#### NEW MEXICO OIL CONSERVATION DIVISION

Re: Application to Amend Order SWD-1699
Mesquite SWD, Inc.
Trey SWD Well No. 1
API No. 30-025-45029
200' FNL & 200' FEL, Unit A
Section 21, T-23S, R-32E, NMPM,
Lea County, New Mexico

Administrative Order SWD-1699 November 3, 2017

Pending Application to Modify High-Volume Devonian Disposal Well C-108 Application for Trey SWD No. 1 – Mesquite SWD Inc. – 10/12/2018

**Exhibit No. 3 Proposed Wellbore Configuration Application to Amend SWD-1699 Trey SWD Well No. 1**

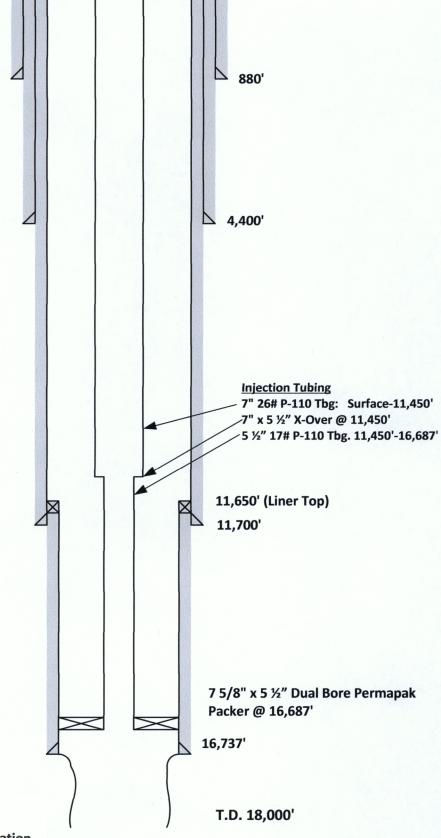
Mesquite, the operator of the Trey SWD No. 1, respectfully requests that Order SWD-1699 be amended to authorize the use of 7" tubing or smaller inside the 9 5/8" intermediate casing and 5 ½" tubing or smaller inside the 7 5/8" liner.

- 1. Copy of Order SWD-1699 (Exhibit 1);
- 2. Attached is the wellbore schematic originally submitted with the C-108 application received by the Division on October 18, 2017 (Exhibit 2). Also attached is a wellbore schematic that shows the proposed wellbore configuration (Exhibit 3). (Please note that the casing and cementing program for this well is not being amended);
- 3. OCD GIS map (Exhibit 4) showing the location of the Trey SWD No. 1 and the surrounding 9-section area. An examination of Division records indicates that there are currently no additional Devonian/Silurian produced water disposal wells within this 9-section area;

Exhibit No. 5 Known Pre-Cambrian Faults Application to Amend SWD-1699 Trey SWD Well No. 1

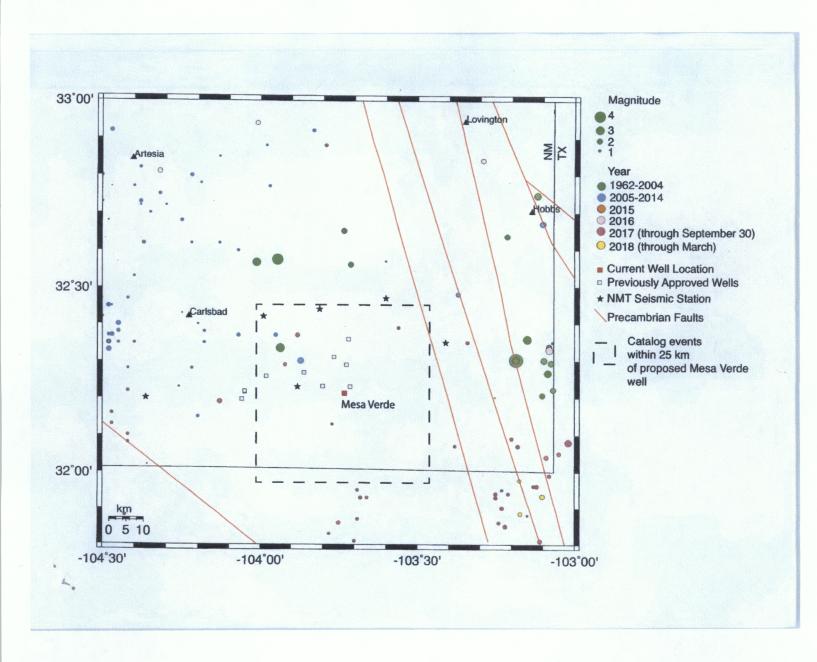
- a. Map of known Pre-Cambrian faults in Southeast New Mexico (Exhibit 5) relative to the location of the Mesa Verde SWD No. 3. (It should be noted that the Trey SWD No. 1 is located approximately 8 miles Northeast of the Mesa Verde SWD No. 3, and still a considerable distance from these known faults);

# Mesquite SWD Increased injection rate per well equates to fewer injectors.

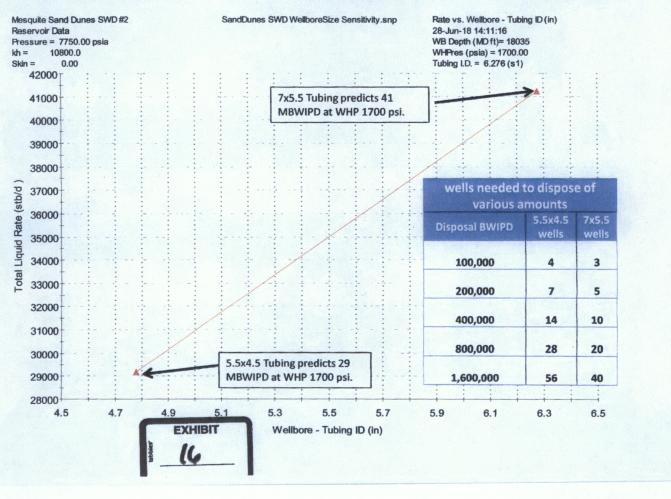
- 7. Attached is a document presented in Case No. 16308 which demonstrates that increasing the tubing size in a Devonian well in this area will result in an increase in injection rate from 29 MBWPD to 41 MBWPD (Exhibit 7). The resulting increase in injection rate will mean that less produced water disposal wells will be necessary to accommodate the ever-increasing demand for disposal.
